Subject: Durham-Orange Light Rail Electrification Impact Study Document
Overview

The objective of this Letter Report is to: 1) Review the LTK EMI modeling and predicted EMF magnetic and electric fields anticipated from the proposed Durham-Orange Light Rail DC traction system, conductors and current flowing from overhead catenary cables; and 2) Provide comments on the LTK emission Zone 3 and predicted magnetic field emissions at various Duke research and medical buildings.

Vitatech performed an initial review of the *EMI Modeling and Evaluation* (Interim Work Product) dated February 2019 for the Durham-Orange Light Rail Transit Project. The interim report is competent and informative; however, there needs to be more detailed information about the potential quasi-static DC electromagnetic interference (EMI) on susceptible ion beam electron microscopy (EM) imaging tools (i.e., TEMs, STEMs, SEMs, FIBs, E-Beams, etc.), medical / diagnostic instrumentation (i.e., NRMs, MRIs, electrophysiology EEGs, EKGs, EMGs, etc.) and sensitive electronic equipment located in nearby commercial, research, medical, and hospital buildings.

Diagram #1, Zone 2 OCS Current – Train WB

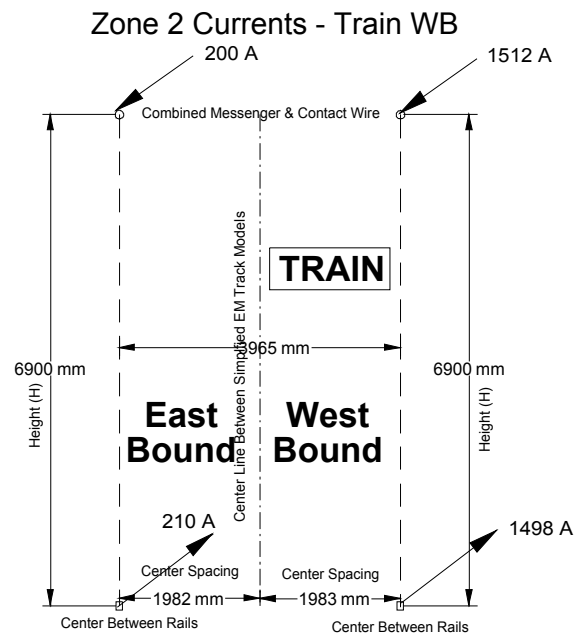
Vitatech generated a simplified quasi-static DC magnetic field simulation model and overlay based upon the worst-case OCS 1512 A current shown in Diagram #1 below:

Figure #1, OCS Durham-Orange Light Rail 1500A Simulation Profile

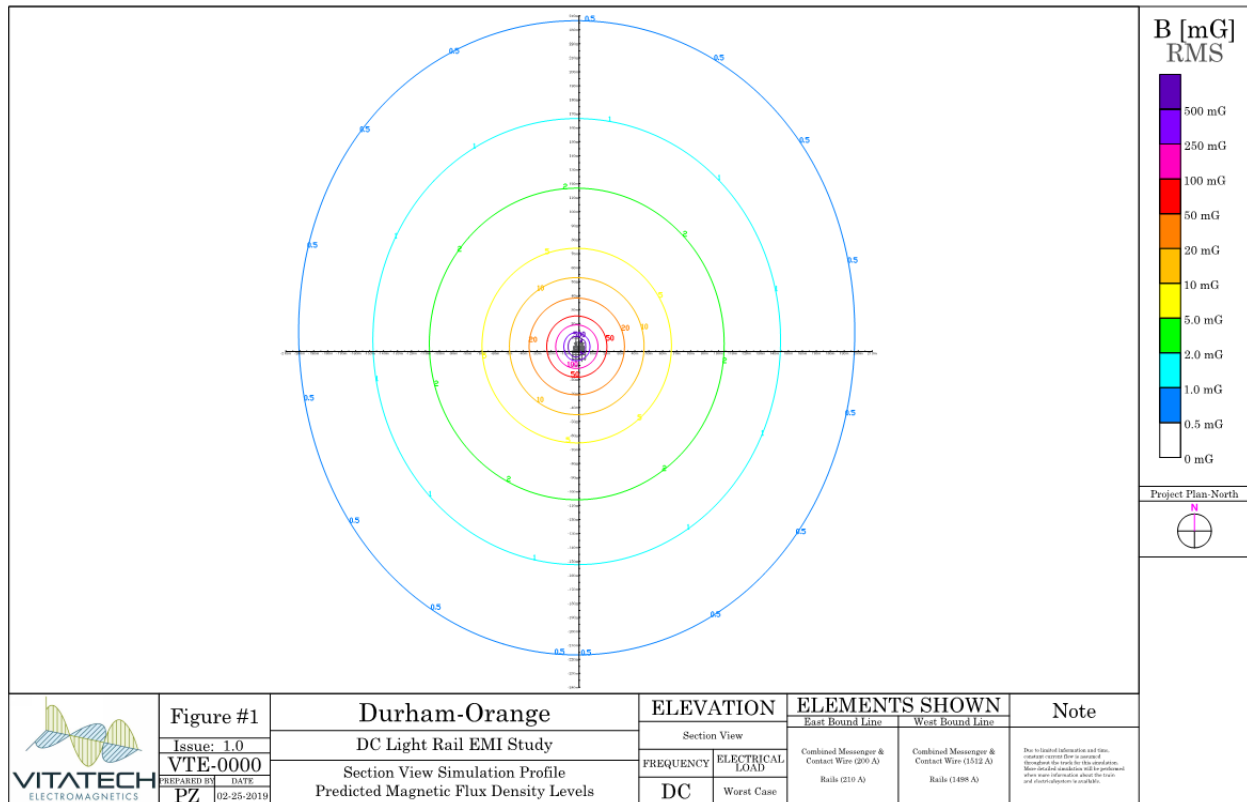
Figure #1 on the next page shows an elevation view of Vitatech's Diagram #1 simulation model at 1500A. The horizontal 0.5 mG RMS isoline is 200m (656 ft.) along the X-axis and the vertical 0.5 mG RMS isoline is 237m (777 ft.) along the Y-axis. This is the worst-case 0.5 mG RMS quasi-static DC extent boundary as the Light Rail cars travel along the alignment. Figure #2, Zone 3, quasi-static DC magnetic field isolines shown on the next page are based upon the 2m elevation (y-axis) slice of Figure #1.

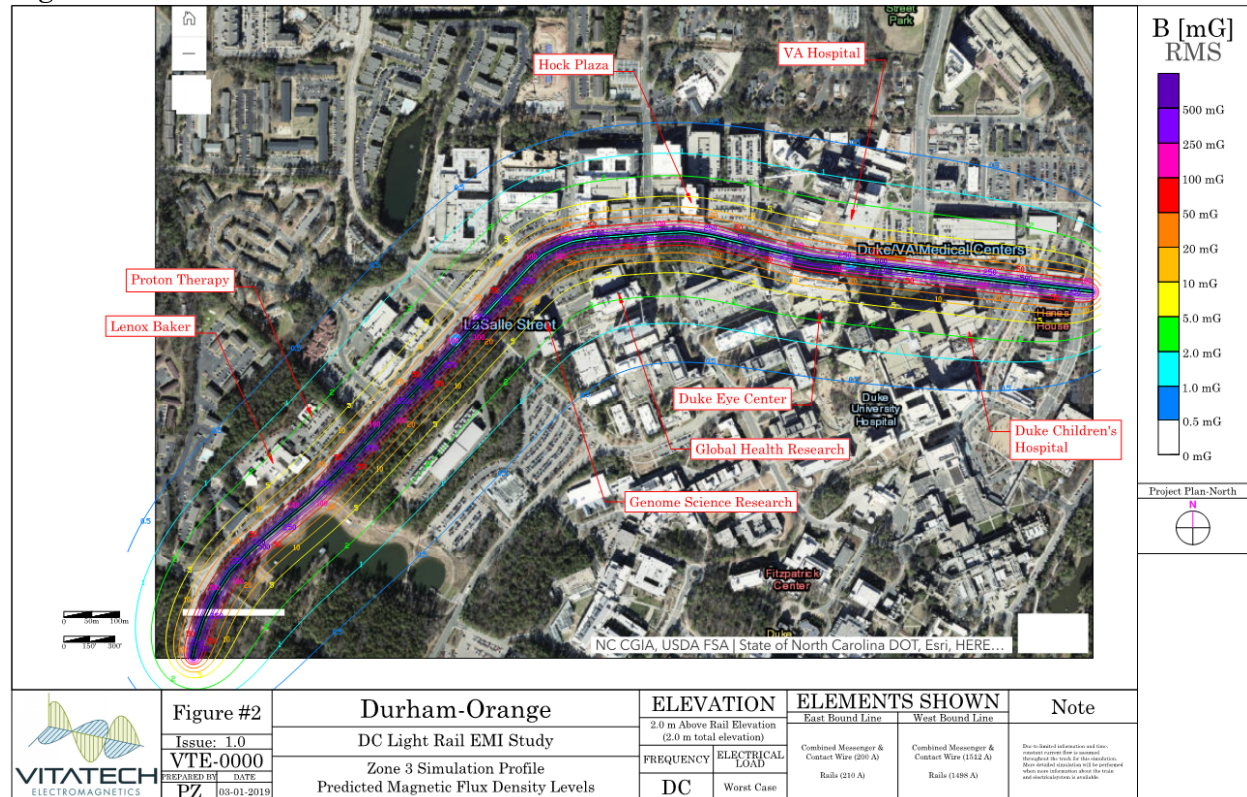
Figure #2 below shows Vitatech's combined Zone 3a & 3b simulation model at 1500A.

Based upon the Light Rail alignment proximity to the Zone 3a and 3b in the Report, Vitatech is very concerned there will be quasi-static DC EMI compliance issues with many of the electron microscopes and MRIs / NMRs. (see Table #1 tool EMI threshold criteria):

It should be noted that the Vitatech Zone 3 simulation model is similar in magnitude to the Report Zone 3a and 3b models; however, our Figure #2 simulation is easier to read with 1 mG RMS and 0.5 mG RMS quasi-static DC isolines for additional detailed resolution and potential EM tool EMI impact susceptibility assessment.
